4. Somerset Street - Midtown Project

**LEGAL ADVERTISEMENT
PORTLAND PLANNING BOARD MEETING**

- i. Midtown Project; Level III Subdivision and Site Plan, Conditional Use, Site Location of Development, and Traffic Movement Permit; Somerset Street; Federated Companies, Applicant. The Board will consider the final plan application for the "midtown" project, which is located in the B-7 zone. The 3.5 acres site is bounded by Somerset Street, Elm Street, the Bayside Trail and the extension of Pearl Street. The mixed-use proposal includes 445 residential units in four buildings with a maximum height of six stories. A seven story parking structure with 828 vehicle spaces is proposed as a conditional use. The total footprint of the buildings is 121,400 sf and the total floor area is 750,200 sf with 87,200 sf of retail space proposed. The workshop will focus on the following topics, but is not limited to: Architectural Design and the B-7 Design Standards and Waivers; Stormwater Management; Somerset Street Design; Traffic Movement Permit; Pedestrian Circulation; and Civil Engineering Waivers.

DRAWN: KEW/LA
DESIGNED: WGH/BEK
CHECKED: WGH/SRB
FILE NAME: 3062-GRADE
SHEET: C-3.1

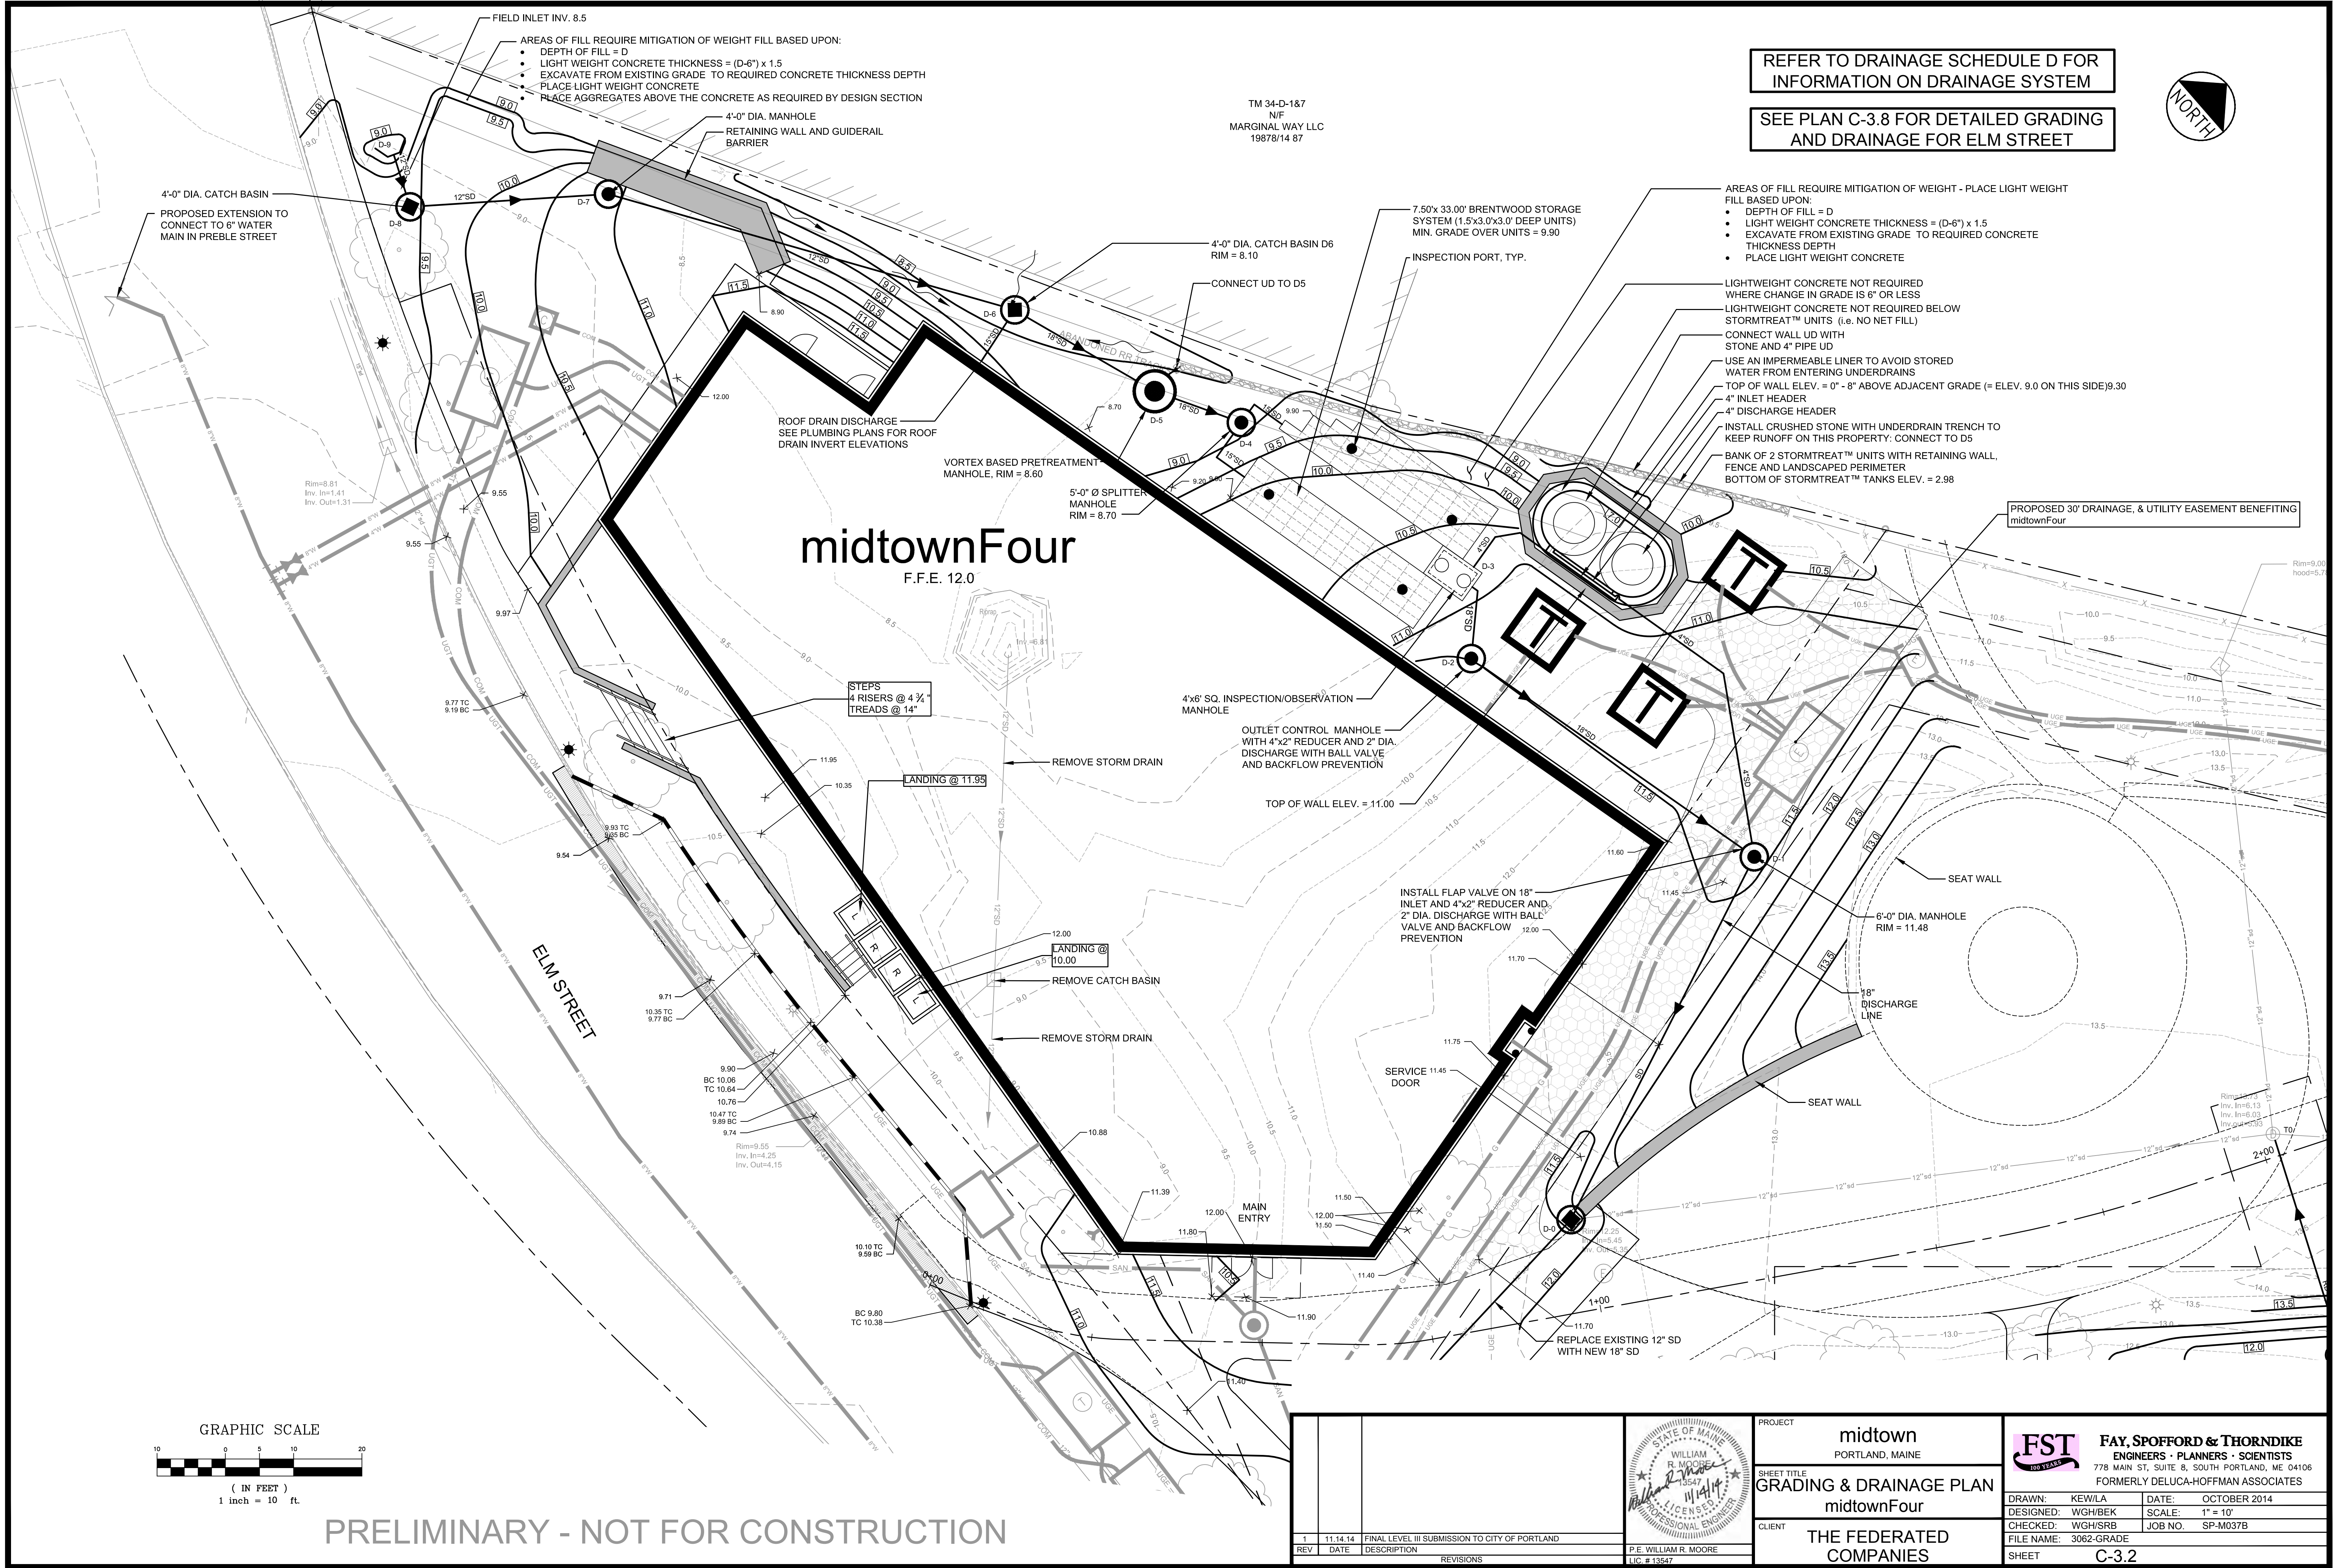
- The easement areas depicted on certain plan sheets are not consistent with the easements identified on Sheet C-1.2 (Amended Subdivision/Recording Plat); for example, sheet C-3.1 depicts an old easement alignment that does not correspond to the underground electrical infrastructure behind midtown 3.

8. The easement areas depicted on certain plan sheets are not consistent with the easements identified on Sheet C-1.2 (Amended Subdivision/Recording Plat); for example, sheet C-3.1 depicts an old easement alignment that does not correspond to the underground electrical infrastructure behind midtown 3.

8. The easement areas depicted on certain plan sheets are not consistent with the easements identified on Sheet C-1.2 (Amended Subdivision/Recording Plat); for example, sheet C-3.1 depicts an old easement alignment that does not correspond to the underground electrical infrastructure behind midtown 3.

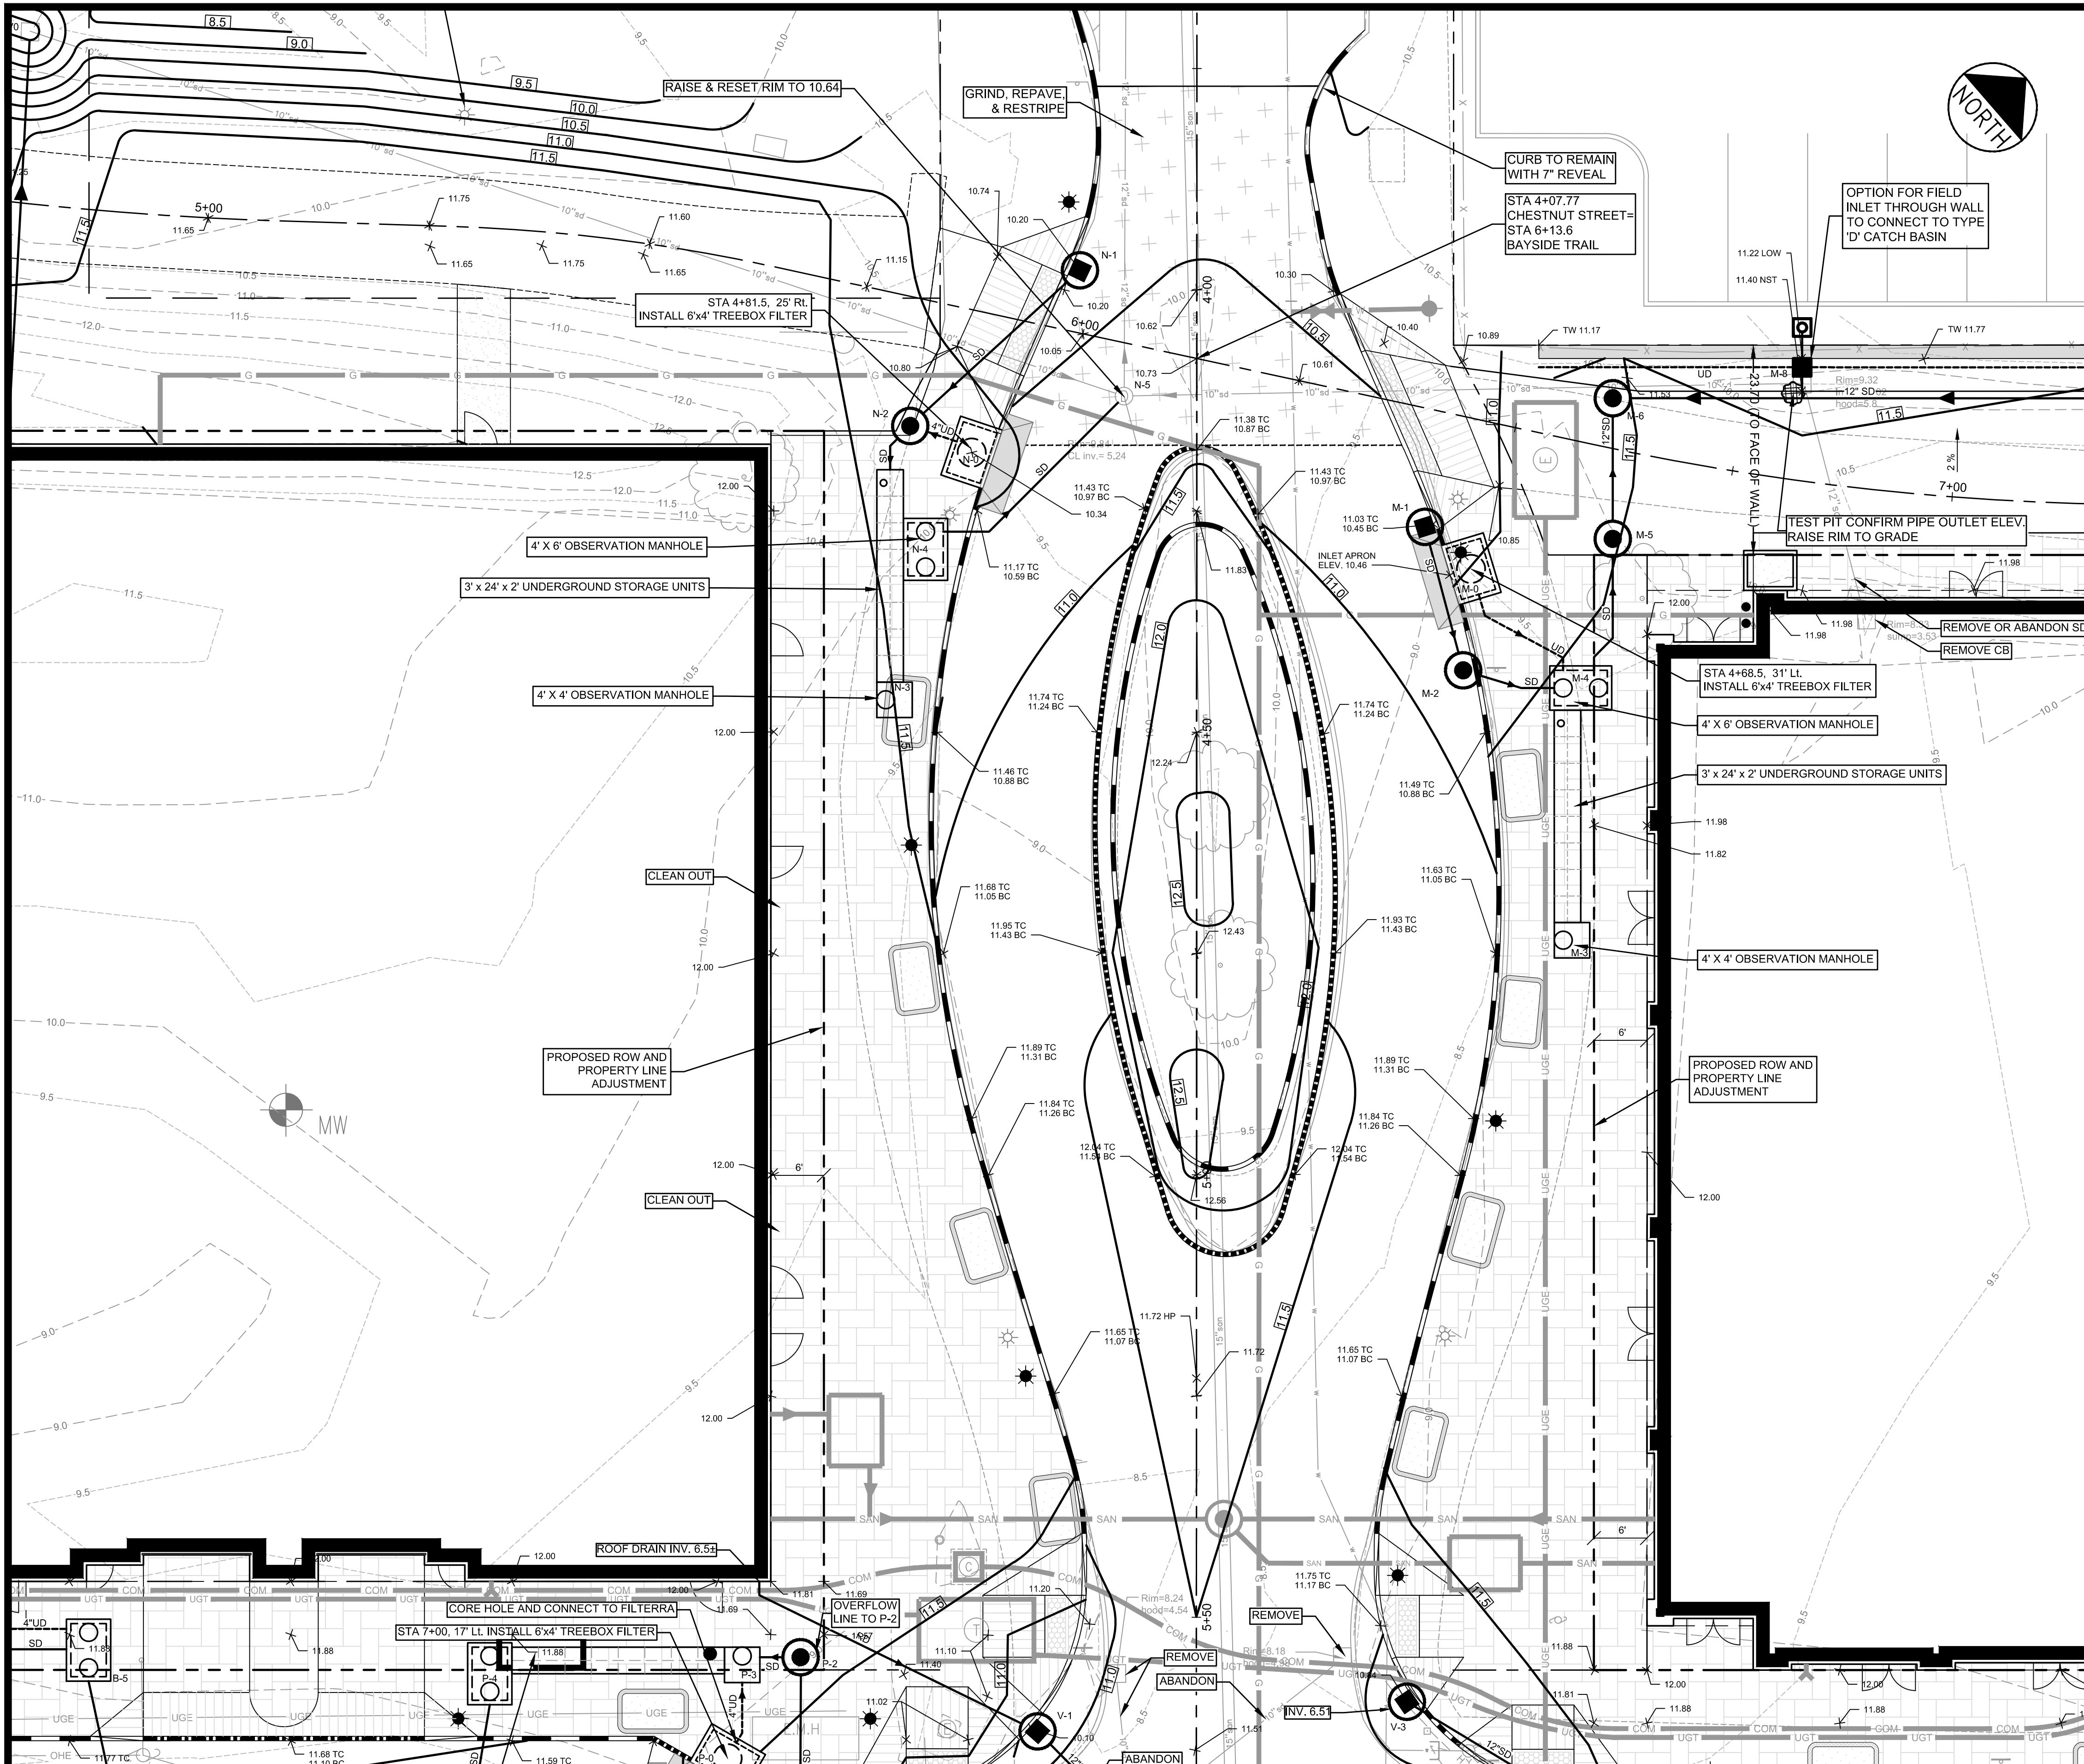
- f. All the proposed underdrain along the face of the Noyes building does not appear to be shown. Drawing C3.4 approximate station 5+25. Please verify.

- g. Please correct 6" SD location from structure S-0. Drawing C-3.4

- e. All the proposed underdrain along the face of the Noyes building does not appear to be shown. Drawing C3.4 approximate station 5+25. Please verify.

- f. Please correct 6" SD location from structure S-0. Drawing C-3.4
